GEOCRES No. 30M13-60

LOCATION C.N.R. Overhead

Ramp 400S-407 E-W

GEOTECHNICAL INVESTIGATION

ABUTMENT ON COMPACTED FILL
SHOWING GRANULAR 'A' CORE

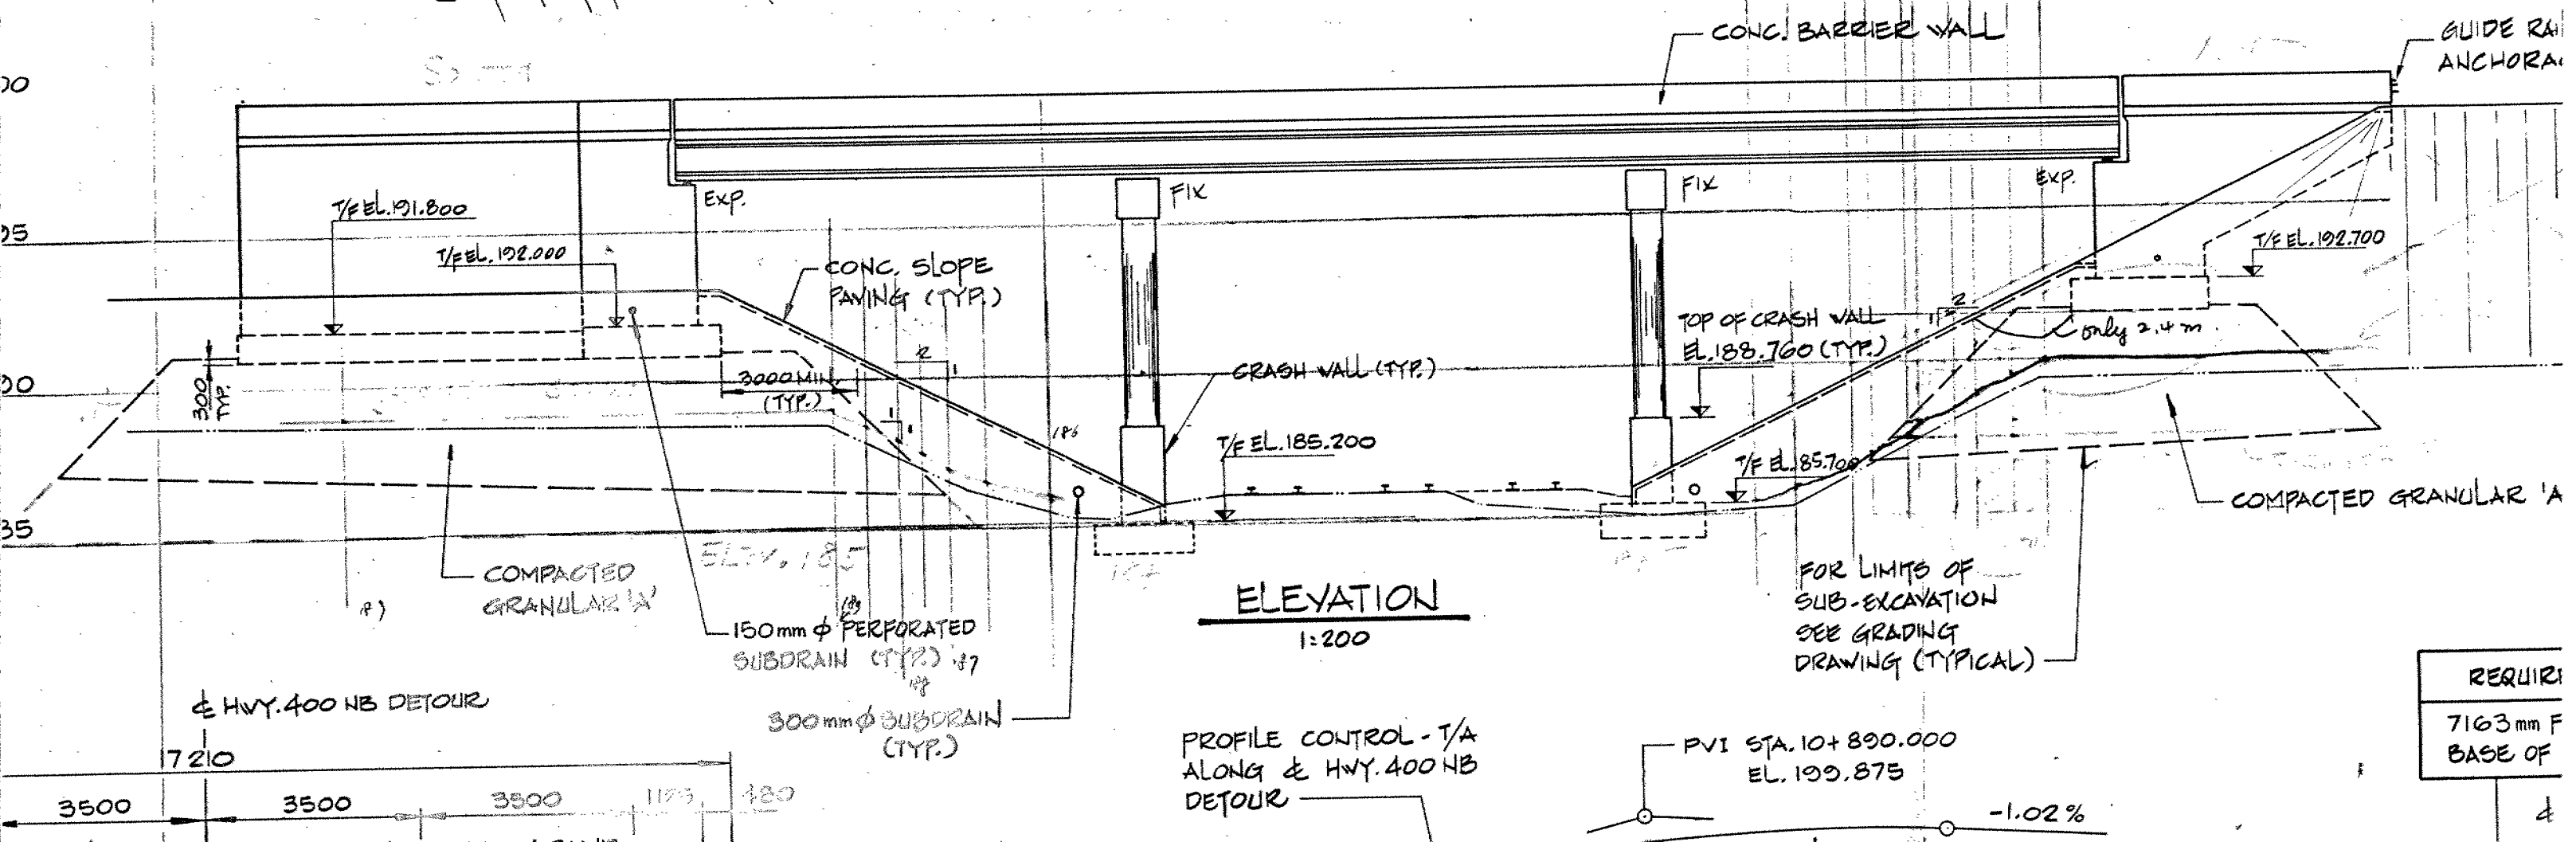
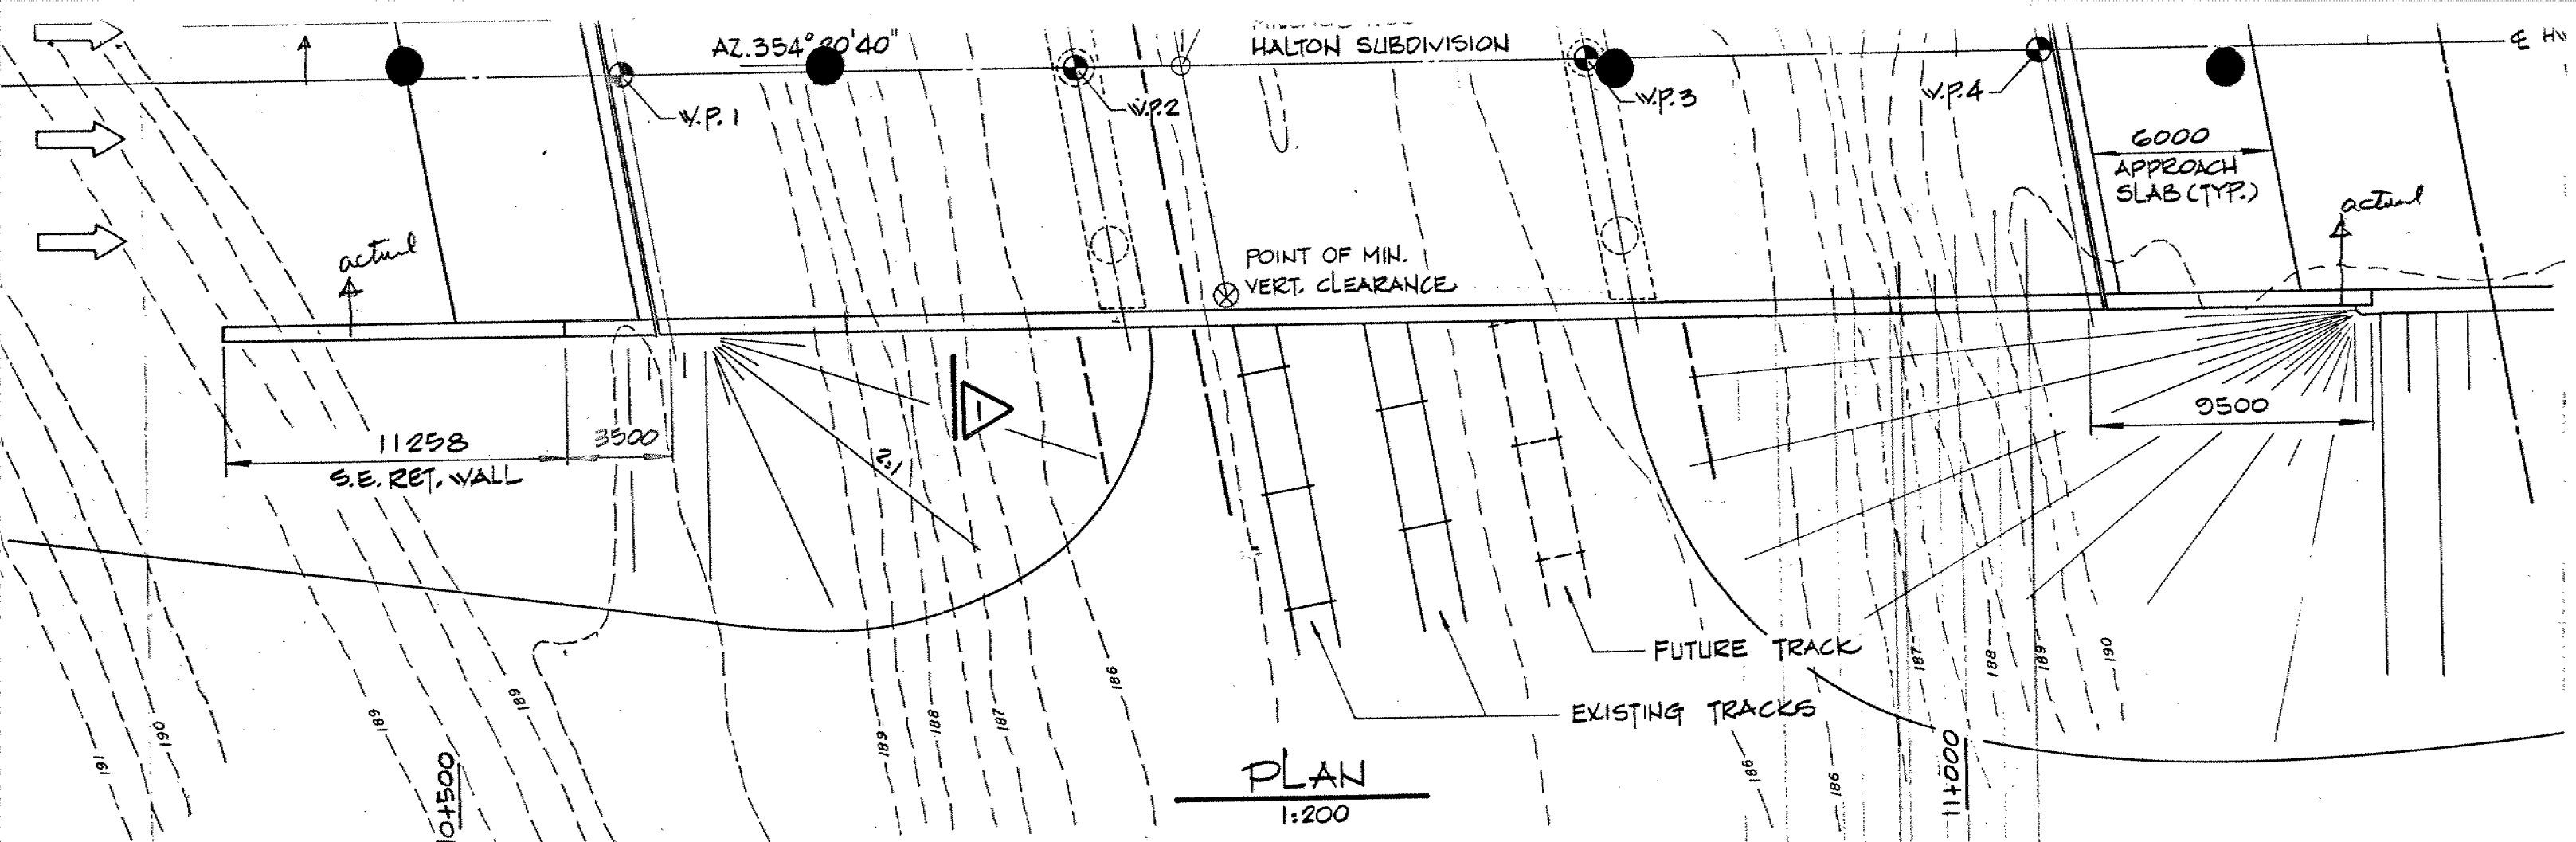
Further to our telephone conversation of September 23, 1987 regarding the placement of compacted granular pad under the abutments footing, the following has been recommended by Mr. Murty Devata.

1. Remove the topsoil, fill and the surficially weathered zones of the upper fill.
2. The granular pad including the earth fill in front of the abutment footing should be 3.0 m minimum.
3. The footing should be anchored 300 mm into the pad.
4. The bearing capacity at Ultimate Limit States is 800 KPa and at Serviceability Limit States is 340 KPa.
5. A sketch of abutment on compacted fill is attached for your information.
